| <b>Well Name:</b> PRECIOUS 30-18<br>FEDERAL COM | <b>Well Location:</b> T23S / R31E / SEC 31 /<br>NENE / 32.266748 / -103.8118 | <b>County or Parish/State:</b> EDDY /<br>NM |

**Notice of Intent**

**Type of Action:** Variance

**Procedure Description:** OXY respectfully requested verbal approval for our Citadel 2 and Citadel 3 rigs for the use of a coflex hose from the choke manifold to gas buster. See the attached communication for reference.

### Citadel 2 and Citadel 3 Choke Manifold Schematic

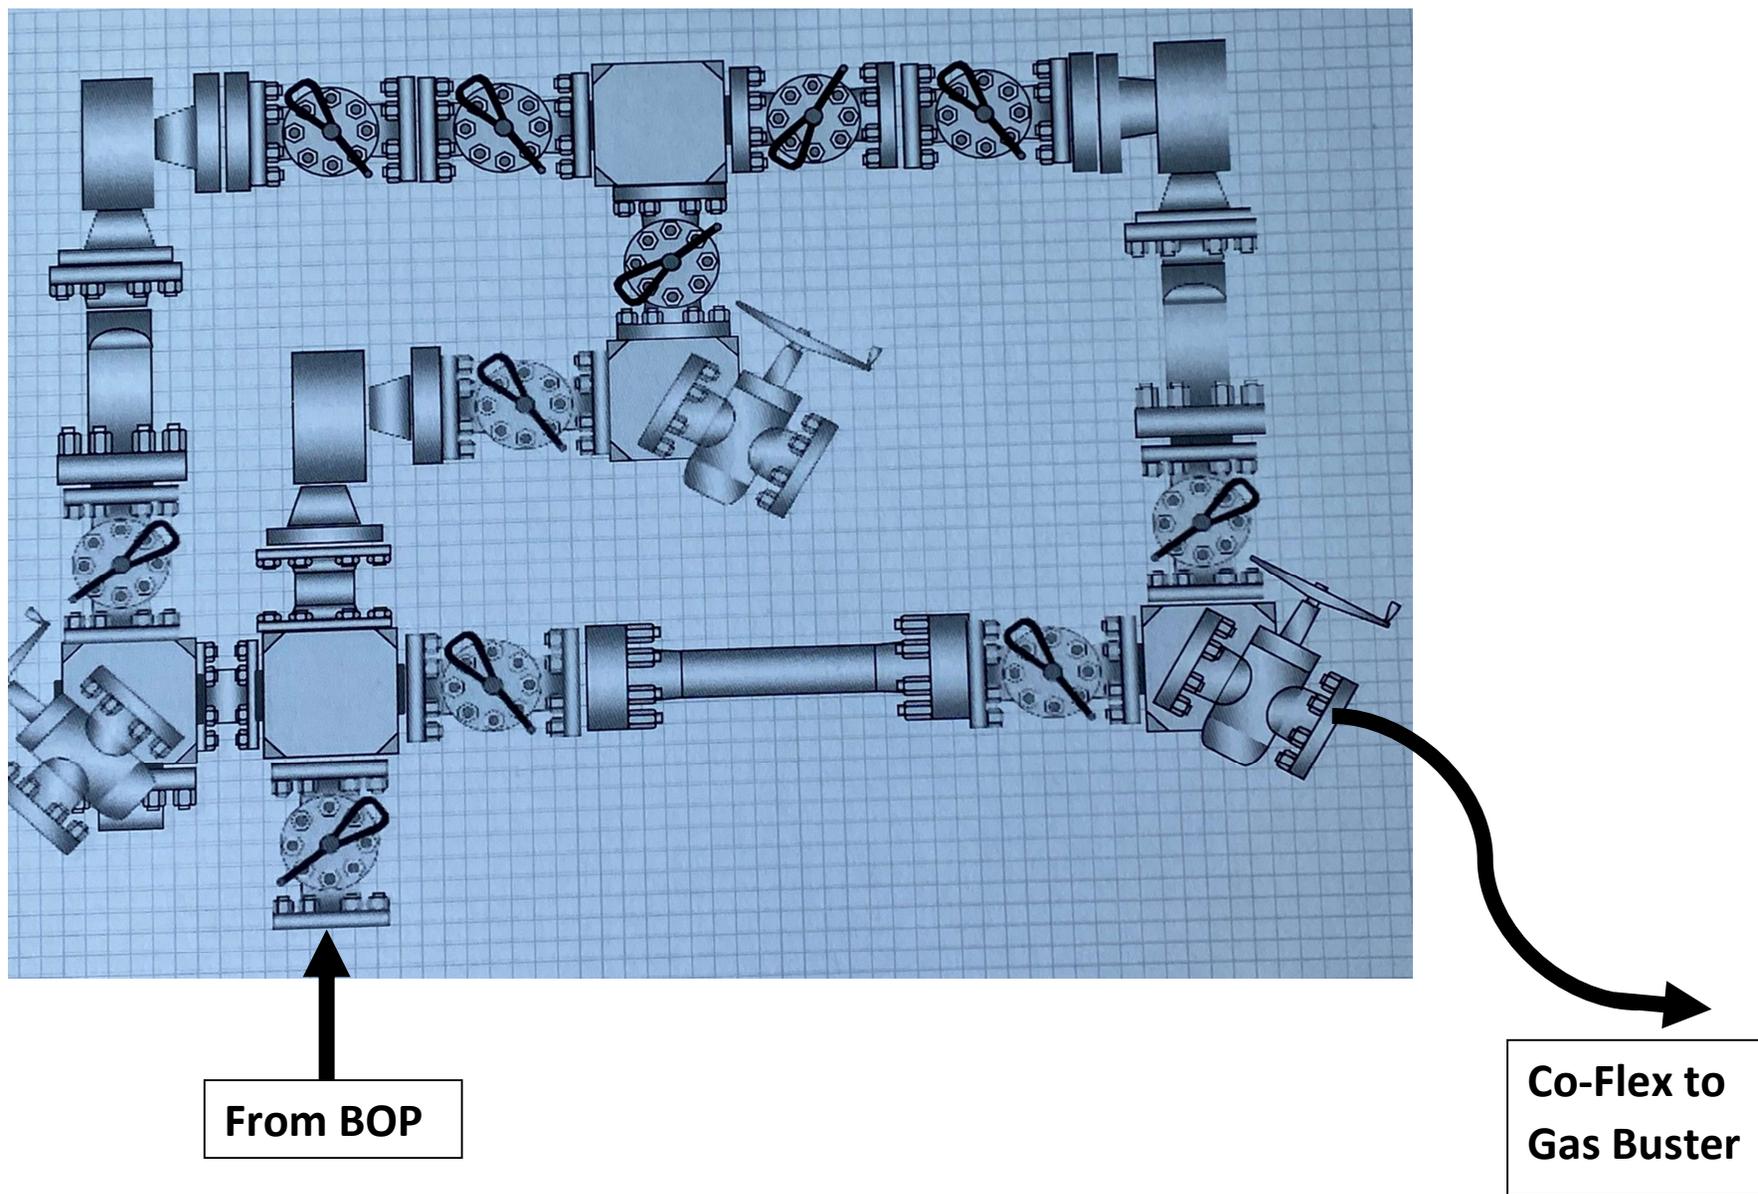
The hammer unions and co-flex hoses are all downstream of the choke manifold and will NOT be subjected to wellbore pressure. Attached is a Choke Manifold schematic of Citadel 2 and Citadel 3 showing the gas buster co-flex hose location.

Received by OCIP: 1/23/2023 12:25:10 PM Page 9 of 12  
**BLM NOTE: Co-flex hoses and hammer unions not intended to and shall not be subjected to well-bore pressure. Existing co-flex scheduled to be changed out in 2023. Reviewed and OK-ed for 5-years from installation date of new co-flex lines. Attached is the schematic of the co-flex on the manifold downstream of the chokes.**
